Improved Flammability Standards for Materials Used in the Interiors of Transport Category Airplane Cabins

[Docket No. 24594; Amdt. Nos. 25-61 and 121-189]

ACTION: Final rule; Request for additional comments.

Figure 1. Release Rate Apparatus

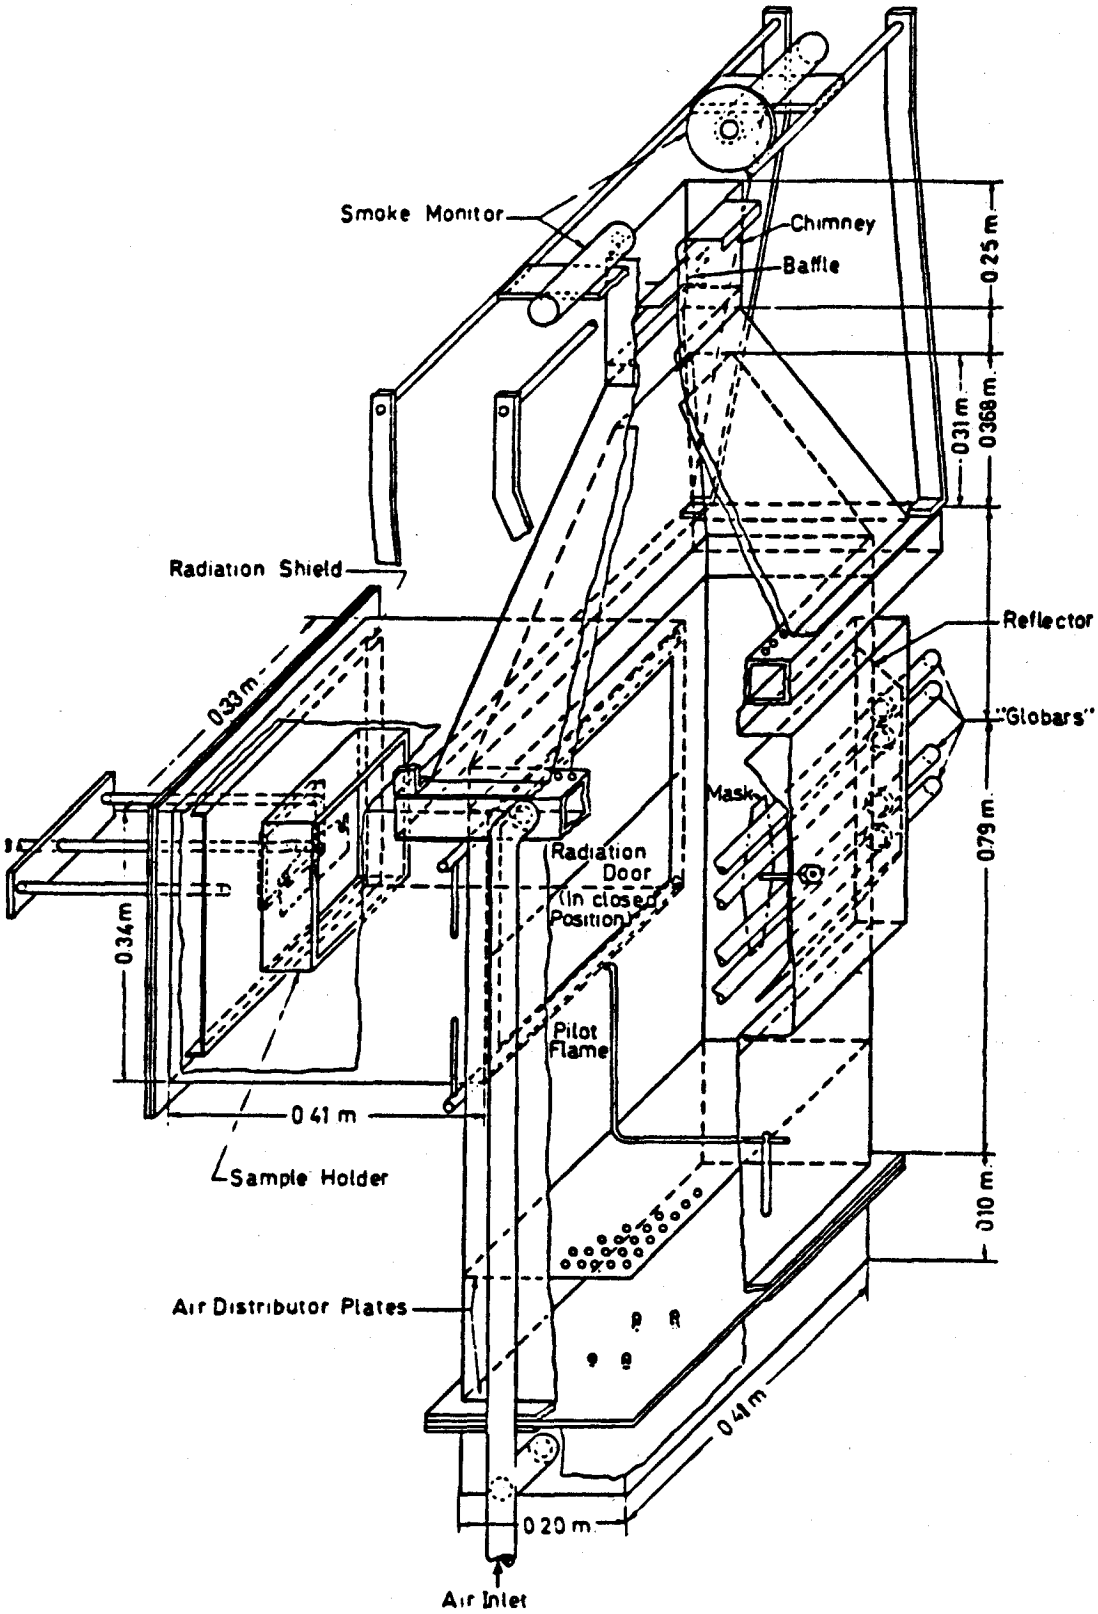
Several commenters note deficiencies in the figures that describe the test apparatus, particularly Figure 1. The figures have been revised to correct these deficiencies and to reflect other changes believed necessary by the FAA. Other commenters note typographical errors in the text of the proposed rulemaking which have been corrected.
